DESCRIPTIVE REPORT

H-8685

HYDROGRAPHIC SURVEY REVIEW

Hawaii, Maui Island, Alaeloa Pt. to Lipoa Pt.

Items for Future Presurvey Review

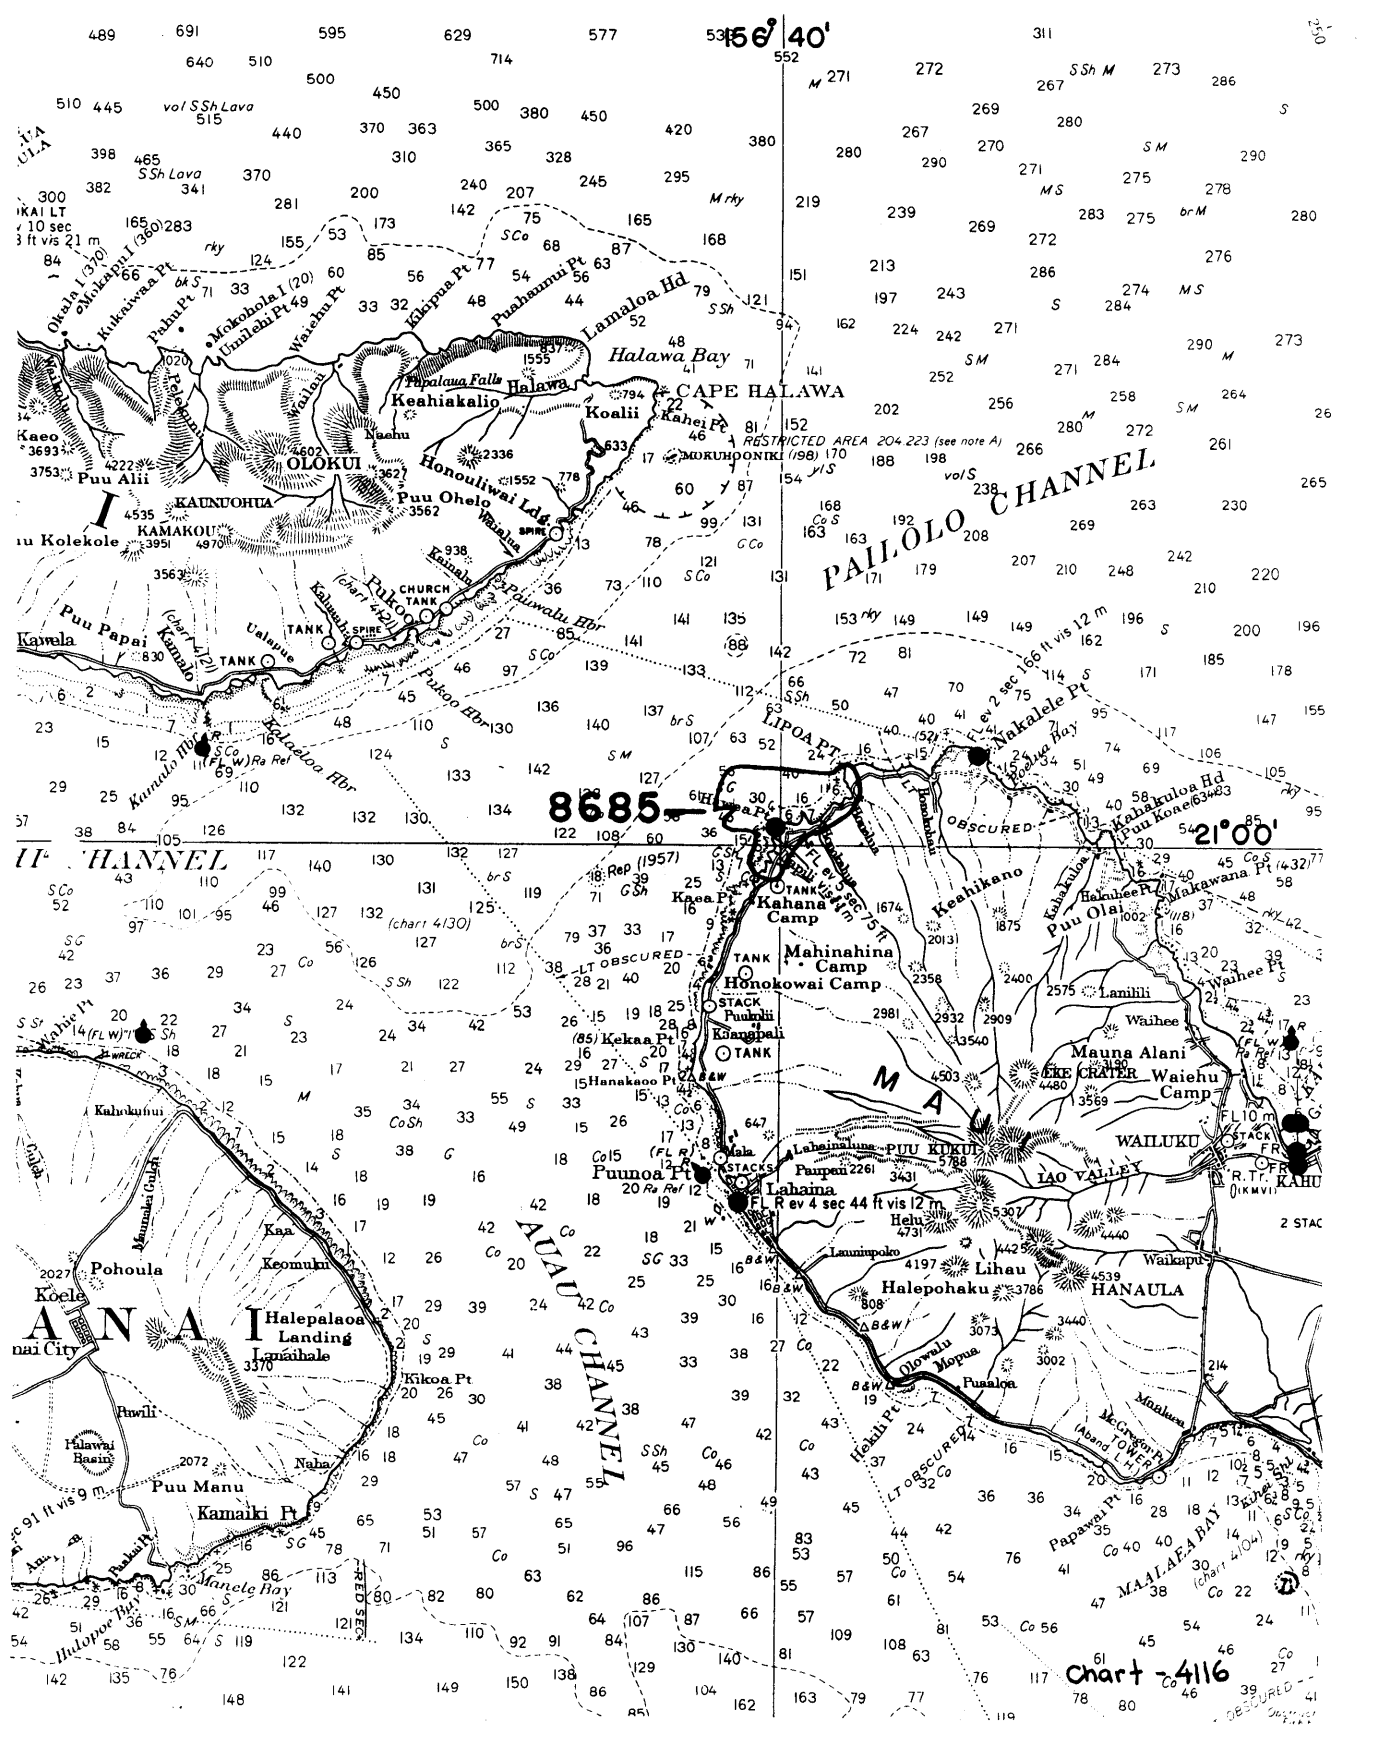
Future surveys should include determination of least depths on the following features:

Depths	Lat.	Long.
5.2	21°00.39'	156°40.33'
5	21°00.66'	156°40.20'
3.5	21°00.57'	156°39.90'
3.7	21°00.77'	156°39.63'
